GREYSTAR CAPITOL HILL

GREYSTAR C.H. DESIGN RECOMMENDATION MEETING

02.15.23 · 1410 E JOHN ST · SDCI #3038146-LU

DEPARTURE 2 – ACCESS ACROSS MORE THAN ONE LOT LINE

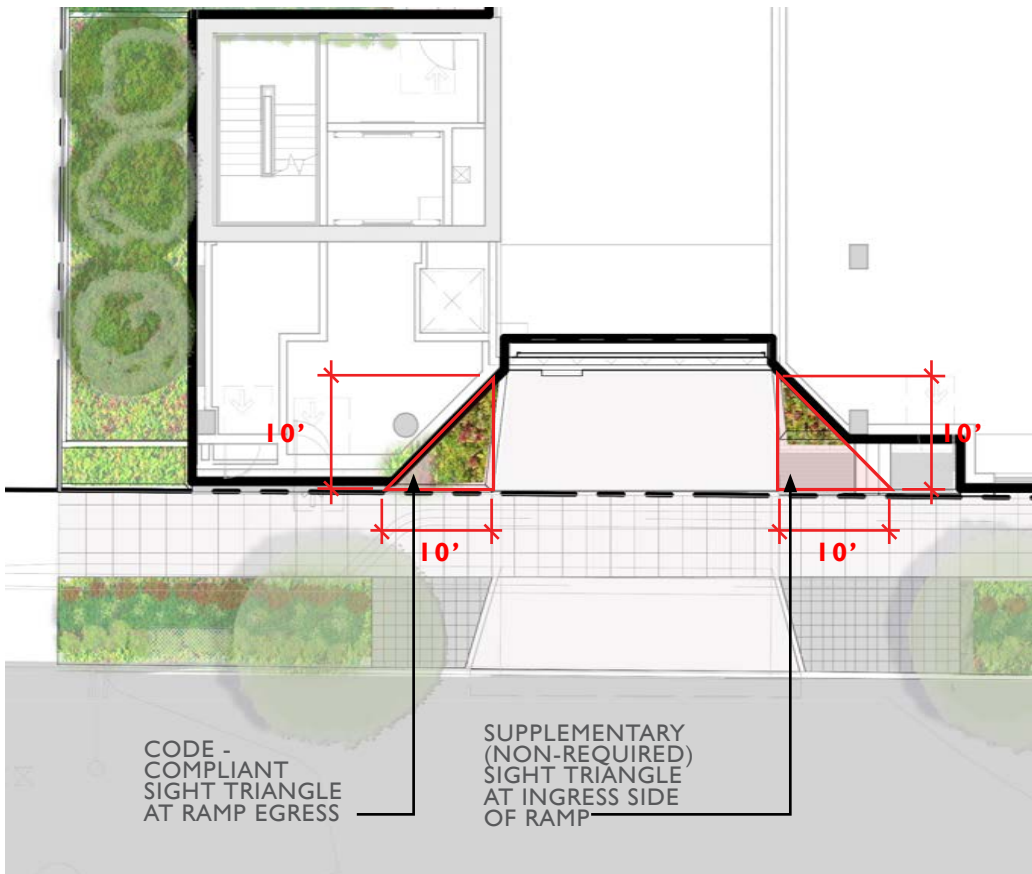
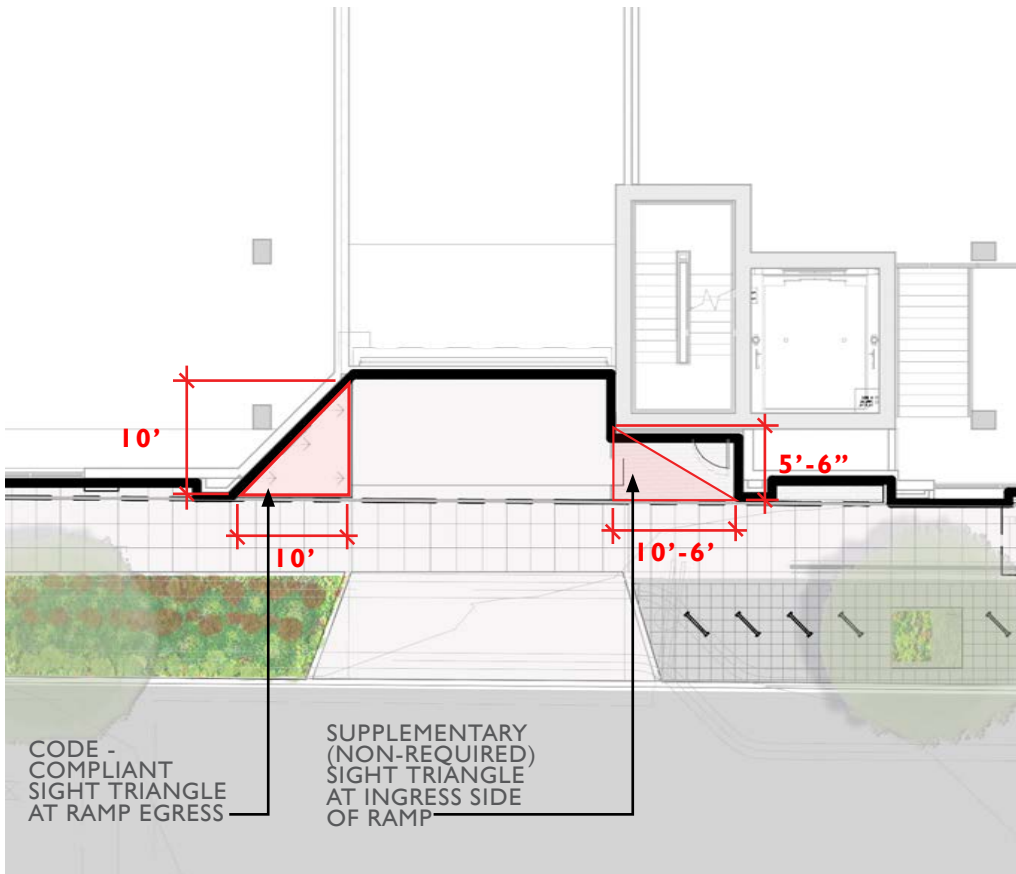
If access is not provided from an alley and the lot abuts two or more streets, the Code allows access across one of the side street lot lines. The lot abuts four streets. The applicant proposes access from two side streets for both massing options, 14th Ave E and E Thomas St. **The Board heard public comment and indicated preliminary support** for the requested departure from vehicular access requirements provided there is **further study of how to minimize pedestrian and vehicle conflicts on 14th Ave E**, as directed in the Priorities and Board Recommendations section above. (DCI-B-1)

Response: The two driveways along 14th Ave E are permitted by code as designed. While this departure request relates to providing access along a second street (Delivery truck and Garbage access from E Thomas St.) safety measures have been provided to increase the safety for pedestrians along 14th Ave E.
